### **AMENDMENTS TO THE DRAWINGS**

### **REMARKS**

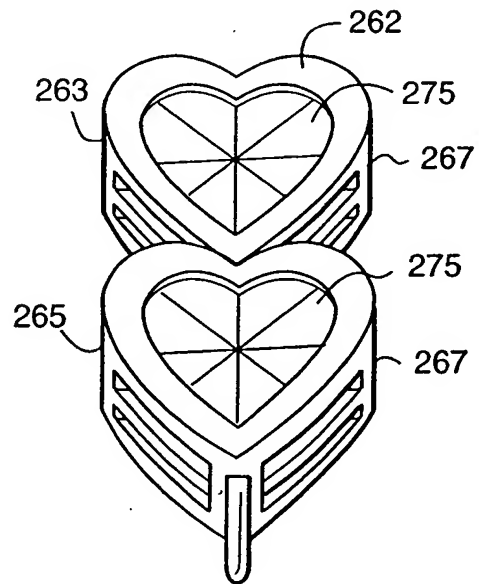
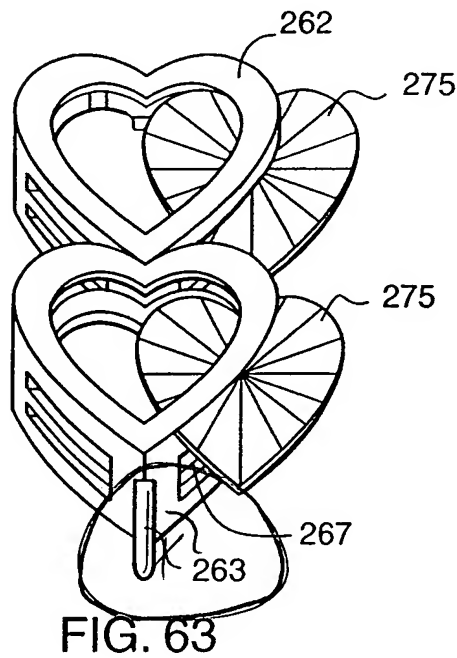
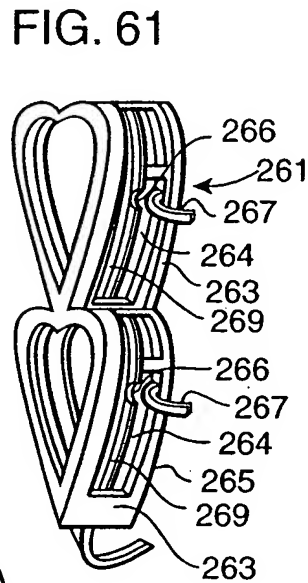
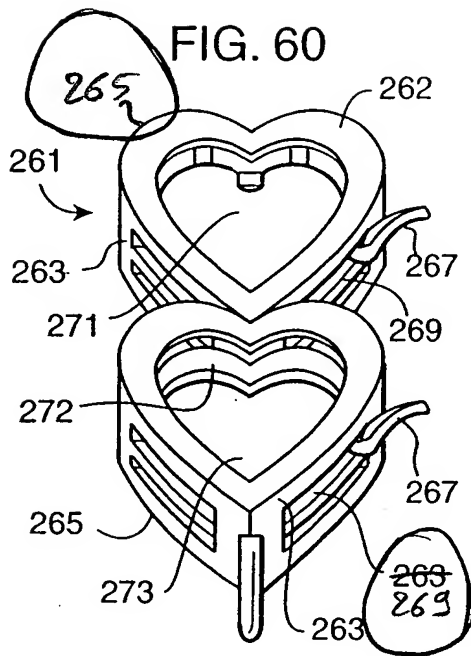
Fig. 60 has been amended so that reference 265 now designates the top segment of the figure as well as the bottom segment of the figure. Further, reference 263 erroneously designating an opening of the bottom segment 265 has been replaced by reference 269.

Fig. 63 has been amended so that reference 263 designates clearly the sidewall of the bottom segment of the figure.

In the Action, the drawings are objected to as failing to comply with 37 CFR 1.84 (p)(4). In particular, the Examiner states that "reference character "263" has been used to designate both sidewall, segment, and what appear to be an opening (Figs 60-61)". Page 33 of the specification and figures 60-61 have been amended so that reference 263 now only refers to the sidewall. The Applicants therefore respectfully request the Examiner to withdraw her objection.

FIG. 81

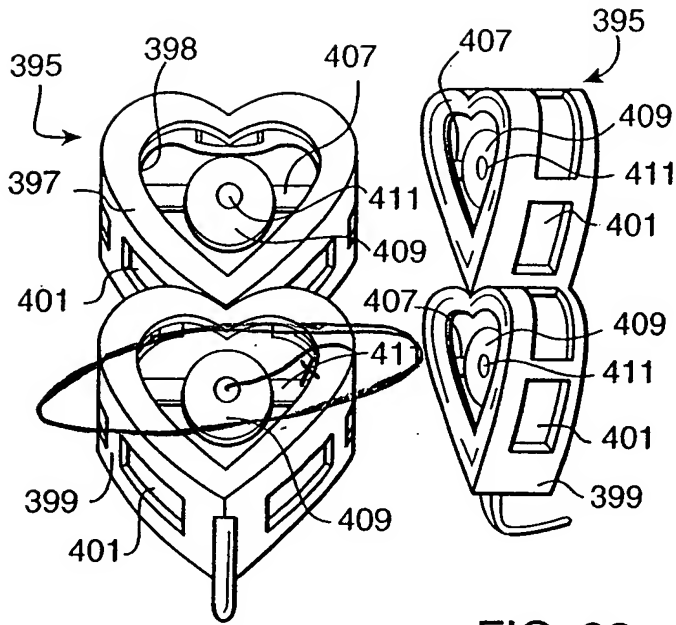
Fig. 81 has been amended so that both references 411 of fig. 81 indicate a hole in support 409 in the top and bottom parts of fig. 81.

In the Action, the Examiner asks the Applicants to check about minor errors in the drawings. Accordingly, Fig. 81 has been amended so that both references 411 of fig. 81 indicate a hole in support 409 in the top and bottom parts of fig. 81 (see replacement sheet 2/2).
